Cree® XLamp® COB LED Product Change Notification

PCN Reference Number: CREE-PCN-0956
Date Issued: January 22, 2020

Please be advised that Cree is making improvements to the voltage characteristics of XLamp® CMA1516, CMT1407, CMT1412, CMT1420, CMT1922, CMT1925, CXB1304, CXB1507, CXB1816, CXB2530, CXB2540 and CXB3050 LEDs.

CMA1516

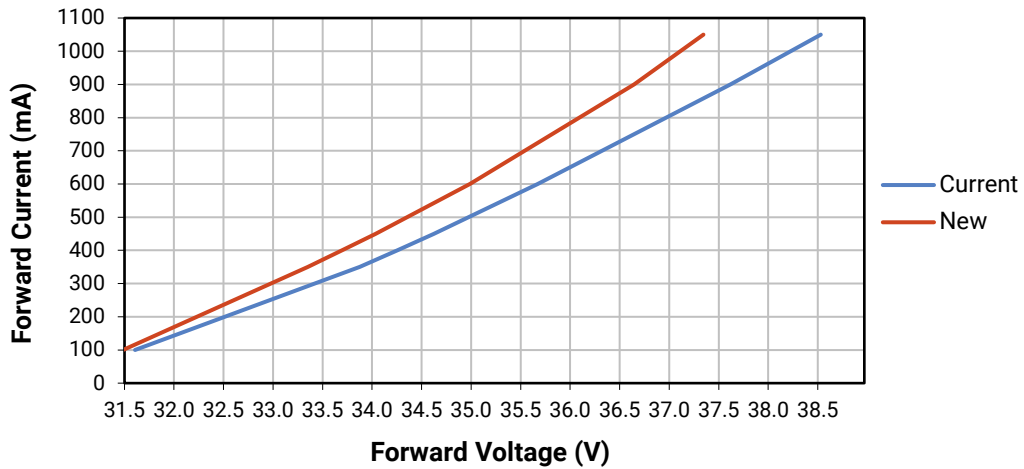
Cree will be changing the typical forward voltage for CMA1516, CMT1407, CMT1412, CMT1420, CMT1922, CMT1925, CXB1304, CXB1507, CXB1816, CXB2530, CXB2540 and CXB3050 LEDs. Table 2 shows the current and new values.

The following graphs show the improved forward voltage vs. current curves.

LED	Typical Forward Voltage	
	Current	New
CMA1516	35 V @ 450 mA, 85 °C	34 V @ 450 mA, 85 °C
CMT1407	34.2 V @ 200 mA, 85 °C	33.7 V @ 200 mA, 85 °C
CMT1412	34.5 V @ 200 mA, 85 °C	34 V @ 200 mA, 85 °C
CMT1420	34.4 V @ 550 mA, 85 °C	34 V @ 550 mA, 85 °C
CMT1922	34.2 V @ 600 mA, 85 °C	34 V @ 600 mA, 85 °C
CMT1925	34.2 V @ 700 mA, 85 °C	34 V @ 700 mA, 85 °C
CXB1304 9 V	8.6 V @ 400 mA, 85 °C	8.45 V @ 400 mA, 85 °C
CXB1304 18 V	17.3 V @ 200 mA, 85 °C	16.9 V @ 200 mA, 85 °C
CXB1304 36 V	34.5 V @ 100 mA, 85 °C	33.8 V @ 100 mA, 85 °C
CXB1507 18 V	17.3 V @ 400 mA, 85 °C	16.9 V @ 400 mA, 85 °C
CXB1507 36 V	34.5 V @ 200 mA, 85 °C	33.8 V @ 200 mA, 85 °C
CXB1816	35.0 V @ 450 mA, 85 °C	34.1 V @ 450 mA, 85 °C
